**CITY OF LA MARQUE
CITY COUNCIL
SPECIAL AGENDA
of
February 3, 2025**

5.III. Change Order #6: Sanitary Sewer Rehabilitation

Re: Texas General Land Office (GLO)
CLO Contract No. 22-083-003-D208
Letter of Justification for Change Order No. 6
Adico Project No. 20100-17

CIPP SECTION 2
CLARK DRIVE
STA 0+00 TO 10+00

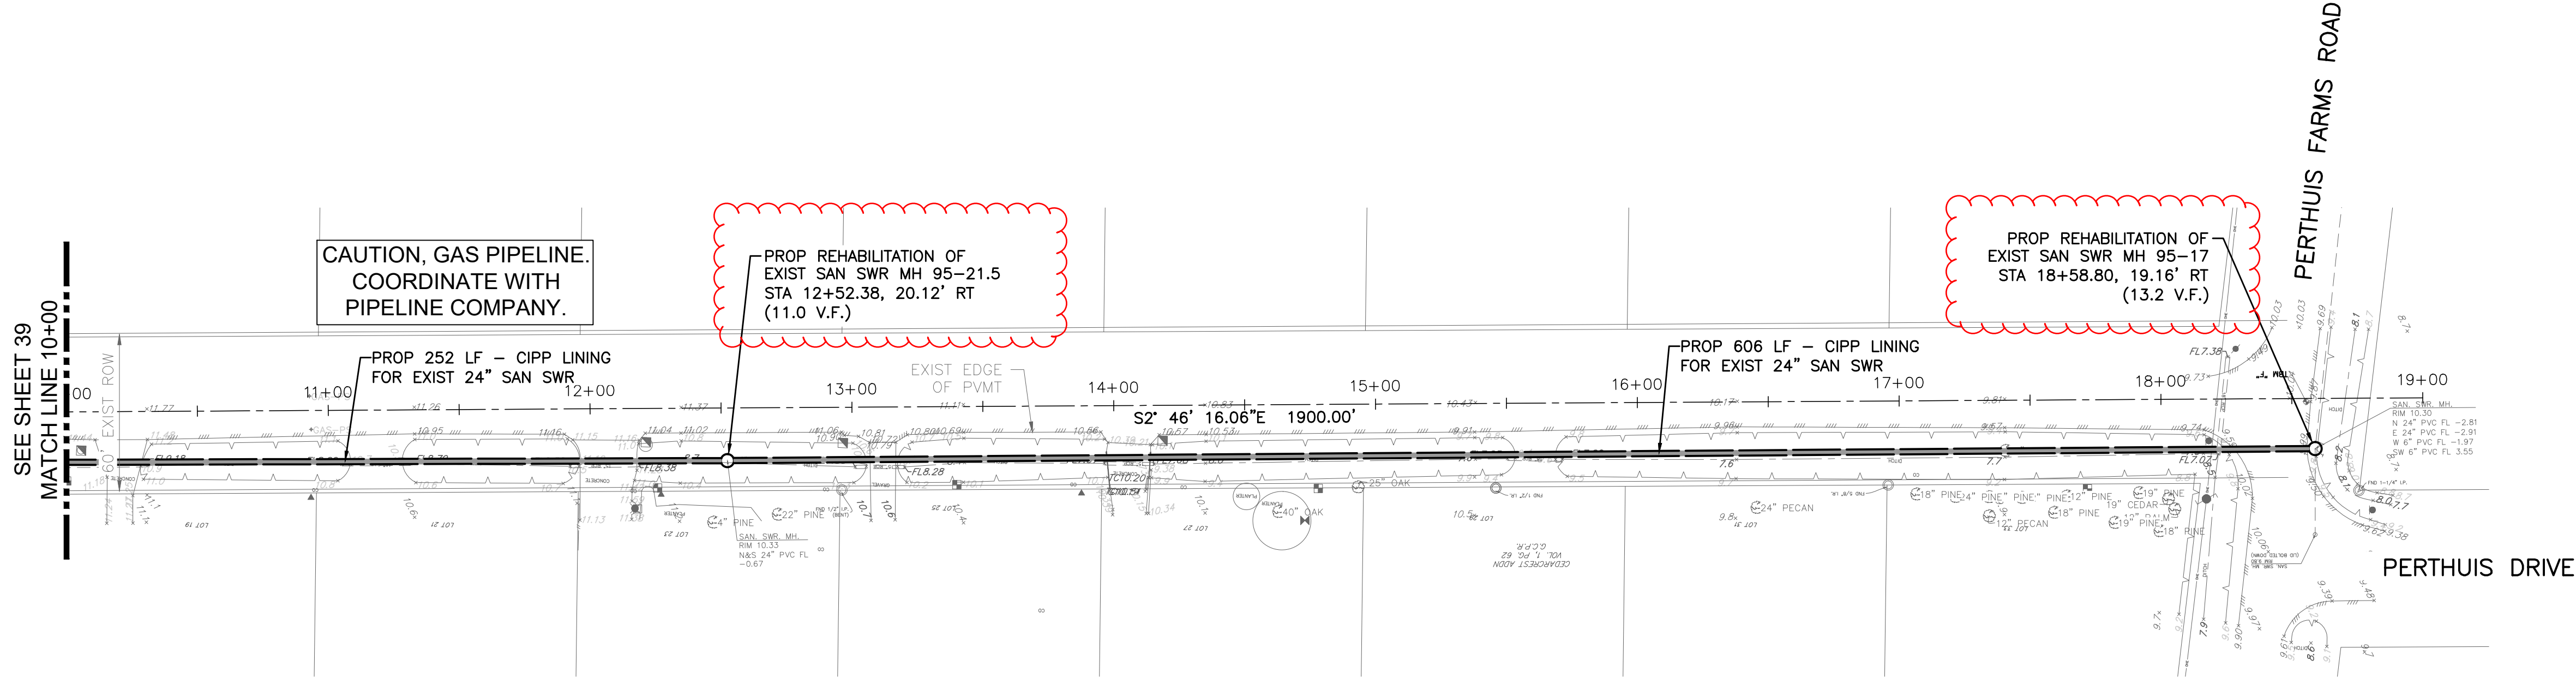
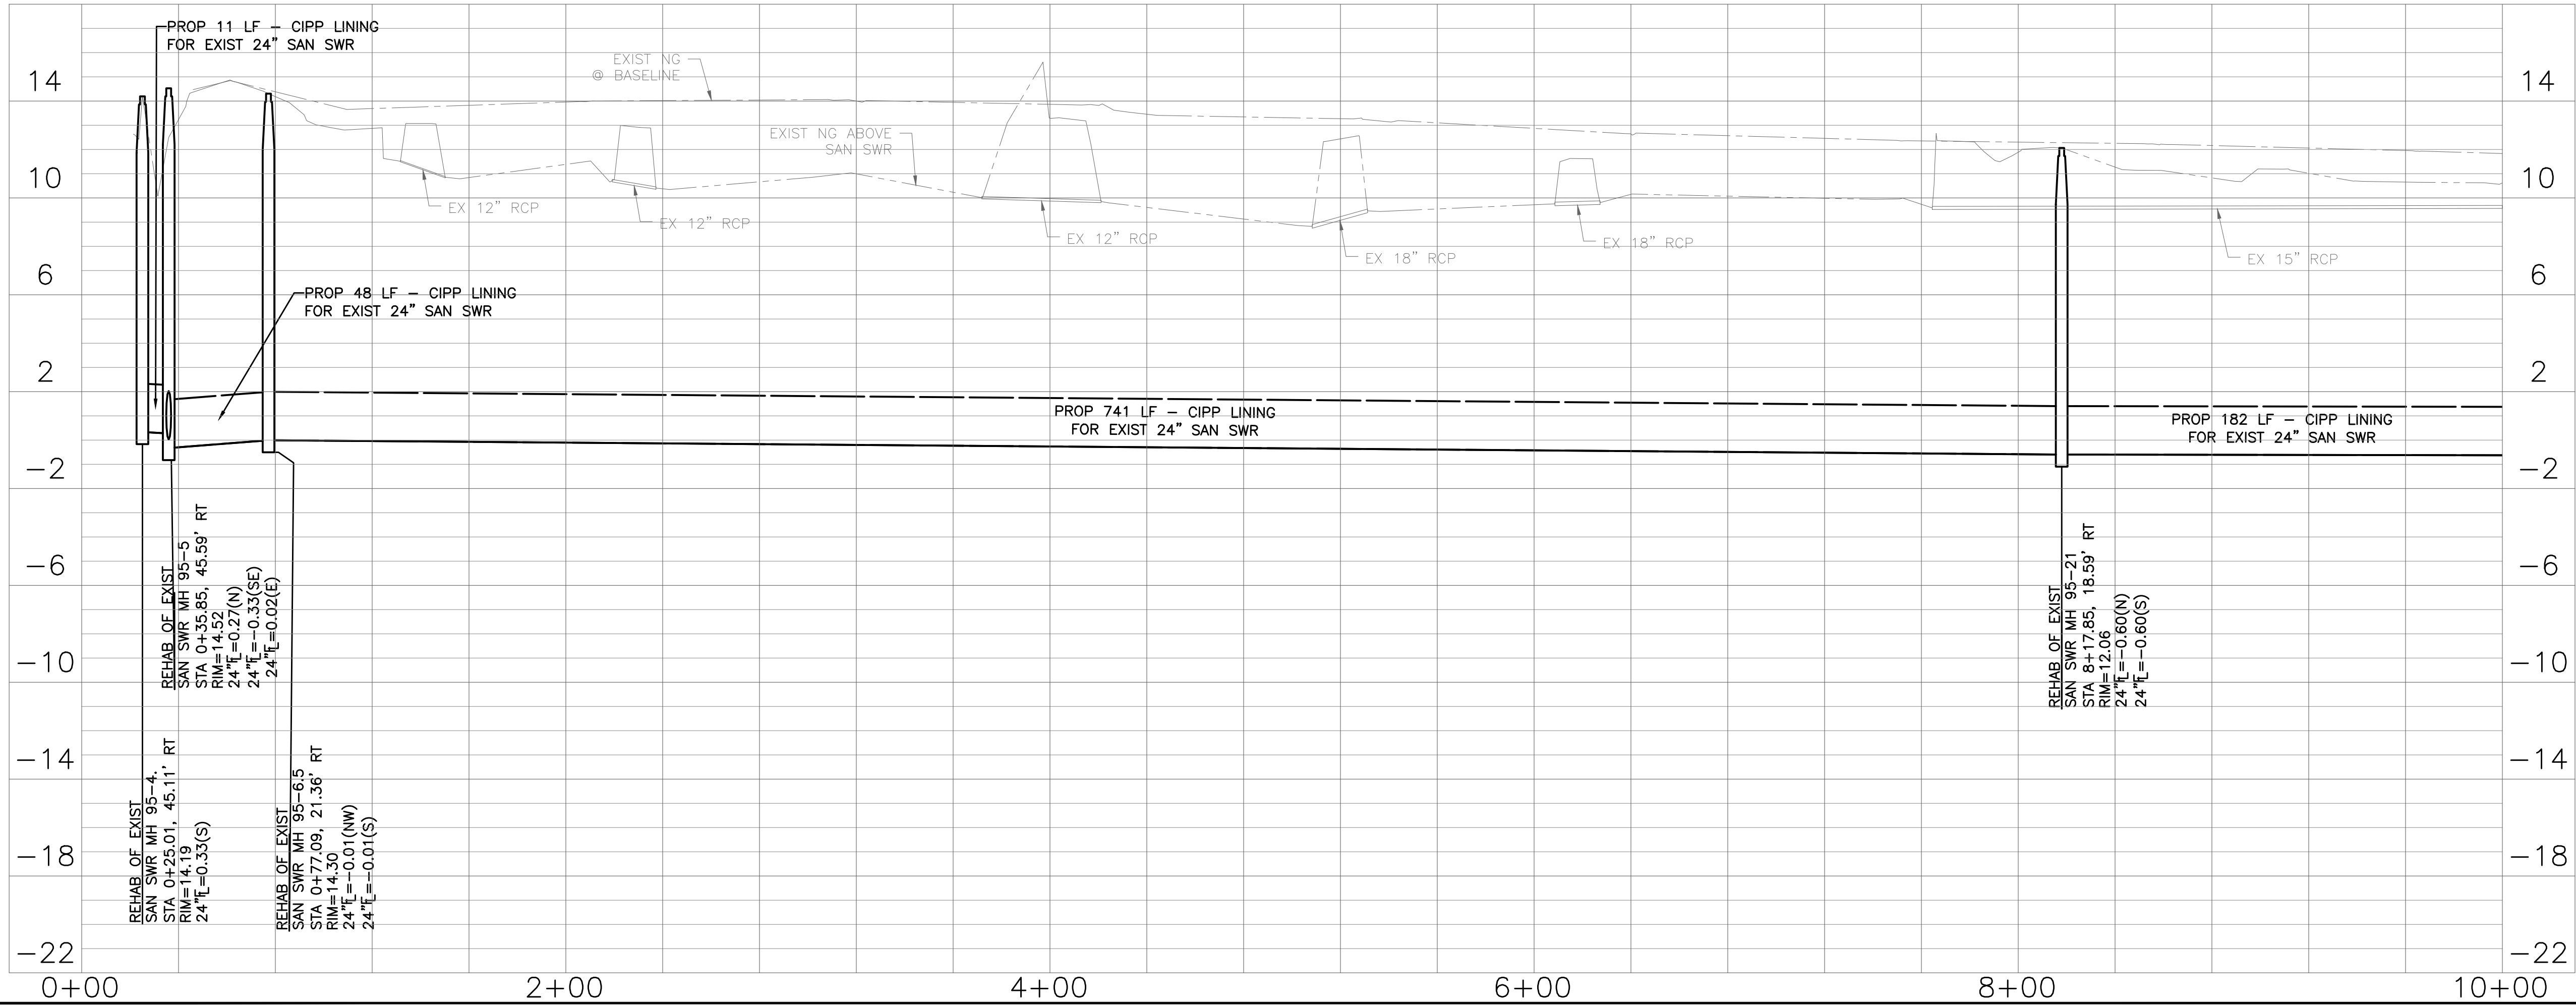
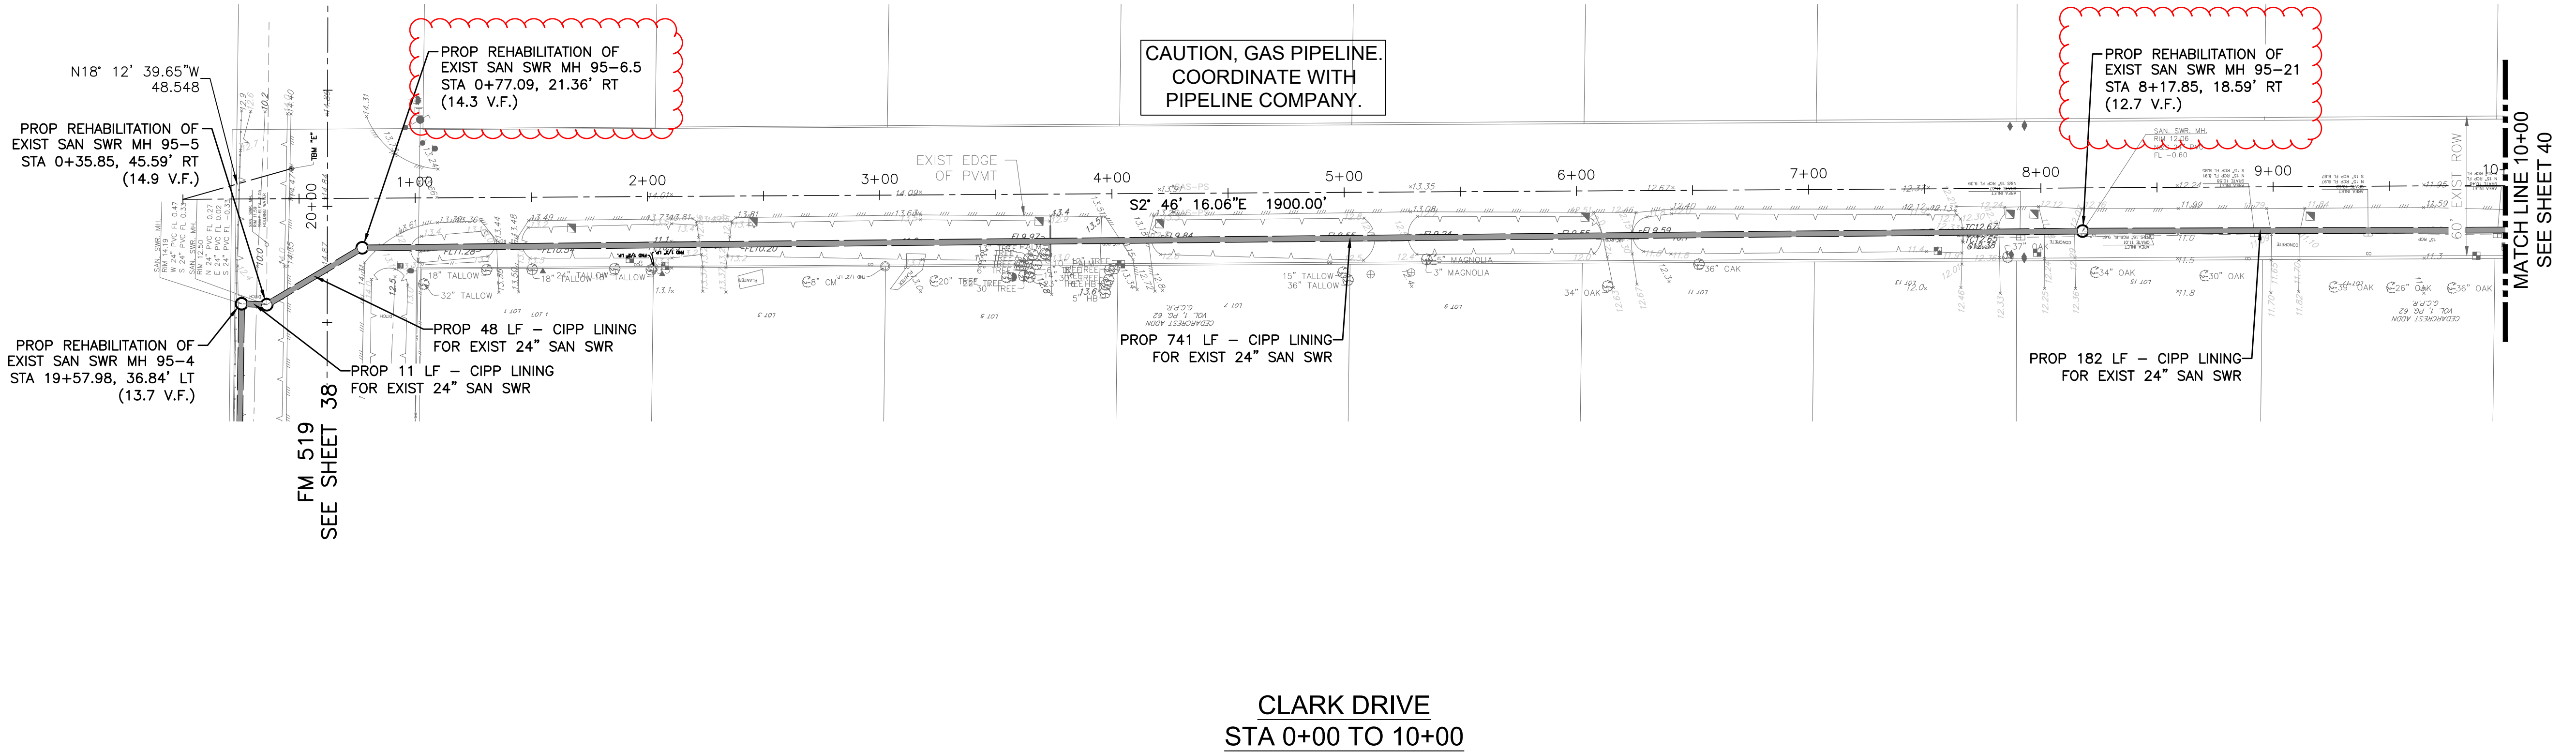
Southern Trenchless, conducted CCTV inspections as part of the pre-construction assessment process in Section 2 of the project and found that it was not necessary to proceed with the original scope of work specified. The original scope called out for CIPP (Cured-In-Place Pipe) lining for the entire length of pipe segments to address potential structural deficiencies in Section 2.

The CCTV inspection revealed that the sanitary sewer system in Section 2 is in good structural condition and free of significant defects. However, the inspection identified specific locations within the pipe segments where I&I (Inflow & Infiltration) leaks were present. These leaks are isolated and do not warrant the extensive rehabilitation originally planned.

In lieu of performing CIPP lining on the entire pipe sections, it is proposed to perform targeted point repairs at the locations where I&I leaks were identified. This approach addresses the identified deficiencies while preserving the integrity of the remainder of the system, which was found to be in satisfactory condition.

Item No.	Description of Changes: Quantities, Units, Unit Prices, Change in Completion Schedule etc.	Decrease in Contract Price	Increase in Contract Price
ITEM INCREASED:			
CO6-1	Internal Pipe Repair for 18" Polypropylene Pipe (Section 2)		\$ 14,300.00
CO6-2	Internal Pipe Repair for 24" Polypropylene Pipe (Section 2)		\$ 37,180.00
CO6-3	Internal Pipe Repair for 30" Polypropylene Pipe (Section 2)		\$ 64,350.00
